SERVICE BULLETIN

No. 629

Piper Aircraft Corporation

Subject: Landing Gear Hose Assembly Inspection and Replacement.

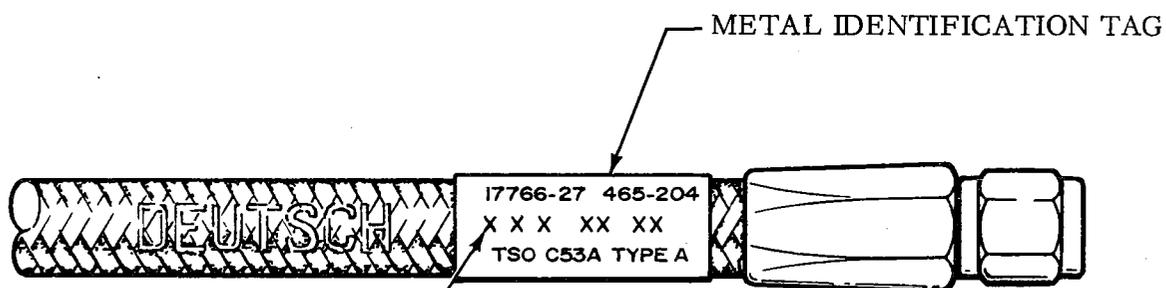
2. Inspect the metal identification tag on the Hose Assemblies for an assembly date of 4Q77 or 1Q78 (See attached sketch).
3. If a Hose Assembly has an assembly date other than 4Q77 or 1Q78, no further action is required. Make an appropriate log book entry of compliance with this Service Bulletin.

INSPECT ASSEMBLY DATE. HOSE ASSEMBLY WITH ASSEMBLY DATE OF 4Q77 or 1Q78 MUST BE REPLACED.

4. If a Hose Assembly is found to have an assembly date of 4Q77 or 1Q78, place the aircraft on jacks (See Service Manual) and proceed with Instructions 5.

5. Remove Hose Assembly(ies) which have assembly dates of 4Q77 or 1Q78. Visually inspect the Hose Assembly for blockage, deterioration or signs of leakage which would indicate delamination.

6. If no evidence of delamination is present, replace the Hose Assembly(ies) with new part(s) having an acceptable assembly date and proceed to steps 6.a. and 6.b.
